SUBJECT: RESPONSE TO THE ADVISORY COMMITTEE ON REACTOR SAFEGUARDS
LETTER, DATED DECEMBER 18, 2013, ON THE STAFF EVALUATION AND
RECOMMENDATION FOR JAPAN LESSONS-LEARNED TIER 3 ISSUE ON
EXPEDITED TRANSFER OF SPENT FUEL

ADDENDUM TO "STAFF EVALUATION AND
RECOMMENDATION FOR JAPAN LESSONS-LEARNED TIER 3
ISSUE ON EXPEDITED TRANSFER OF SPENT FUEL"
STAFF EVALUATION OF MITIGATION SENSITIVITY

Figure ES-1: Likelihood of a leak and magnitude of releases from beyond design basis earthquake

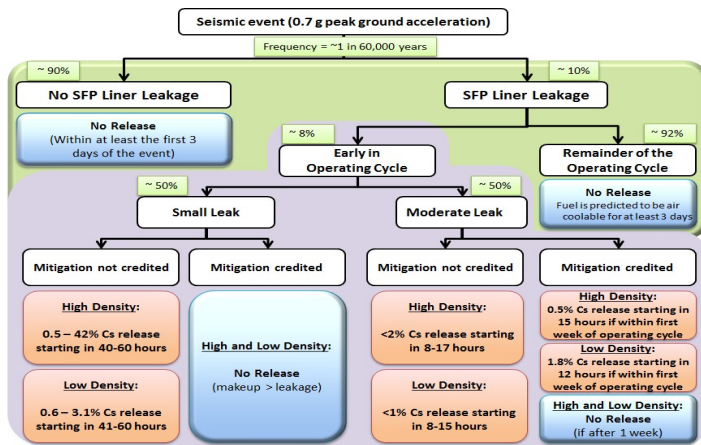
Questions arose during the staff's discussions with the ACRS about when mitigation assumptions are credited, and whether the staff's general explanation of artificially biasing the results towards additional studies might be interpreted as an actual physical phenomenon associated with high-density pools instead of a simplifying assumption and characterization only for the purpose of the evaluation in COMSECY-13-0030. Some members of the ACRS were interested in the possible impact of the above assumptions and asked about sensitivity results beyond what was provided in COMSECY-13-0030 and the associated presentation. Specifically, ACRS members asked for estimates of the cost/benefit analysis assuming a more consistent treatment of mitigation capabilities for both high- and low-density pools, the staff performed some additional evaluations and provides the following results and observations for three cases reflecting different assumptions for the conditional probability of successful mitigation. Case 1 reflects the values in the base case for COMSECY-13-0030 – no mitigation for high-density SFPs and effective mitigation for low-density SFPs; Case 2 assumes no mitigation for either high- or low-density SFPs; and Case 3 is effective mitigation for both high- and low-density SFPs.

Commented [p3]: What does this mean more realistic???? What did ACRS ask for? Suggest delete realistic...it should be clear. Also if you note one Commission office requested information, then you would provide it to all so this detail is not needed.

Because the evaluations for COMSECY-13-0030 were primarily intended to help determine the need for additional studies, the staff elected to simplify the cases and to use conservative estimates to bias the analysis towards beneficial results and the need for further studies. To conservatively estimate the benefits of a transition to low-density storage, the staff selected the high estimated release fractions for the high-density storage configuration (which does not credit mitigation) and credited effective mitigation for the low- density storage configuration. The difficulty in being more precise is reflected in the following excerpt from the SFP Study: :

For Case 2 where mitigation is not credited for either high- or low-density SFPs, the change in calculated benefits is relatively small because of the small increase in the release fractions for low-density SFPs (i.e., a change from no release to 3%). When mitigation is not credited for either loading pattern, the estimated costs exceed the calculated benefits for the base cases and for Groups 1 and 2 for the sensitivity calculations assuming \$4000 per person-rem and contaminations beyond 50 miles. The sensitivity calculations for Groups 3 and 4 are marginally cost beneficial for low density loadings although the safety benefits would still not meet the safety goal screening threshold. These results for the additional case with no mitigation credited for either high- or low-density loadings are the same as the results presented in COMSECY-13-0030 with the assumption of credit for mitigation for low-density pools and no credit for mitigation for high-density pools.

For Case 3 where mitigation is assumed to be successfully deployed, the frequency of fires and related releases from high-density SFPs would be significantly reduced. For this case, the estimated costs far exceed the calculated benefits. The cost/benefit assessment is less supportive of additional studies of expedited transfer of spent fuel when effective mitigation capabilities are assumed.

In summary, the staff's assumption to credit mitigation for low-density but not for high-density SFPs in COMSECY-13-0030 is a conservative assumption meant to increase the benefits of expedited transfer of spent fuel for the purpose of a screening type assessment. If mitigation is not credited for either high- and low-density SFPs, the calculated benefits would only be slightly reduced from those provided in COMSECY-13-0030 and the conclusion remains the same (costs generally outweigh benefits). If mitigation is credited for both high- and low-density SFPs, the calculated benefits would be significantly reduced for all cases and the conclusion becomes stronger (costs far outweigh benefits).
